EX5100 PEEL BAR MODIFICATION

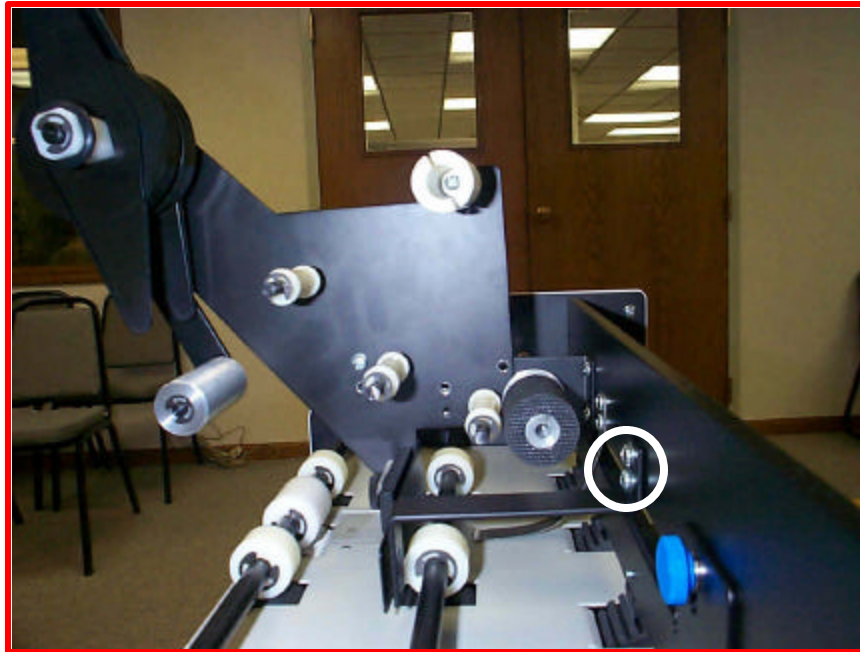
When running some translucent tabs, it may be necessary to decrease the amount of distance between the tab sensor and the peel bar.

1. Remove the two Phillips head screws and star washers from the mounting bracket.
2. Line up the two plastic spacers on the back of each screw.
3. Put the Phillips head screws back into the feed frame.
4. Reassemble the parts back onto the machine.
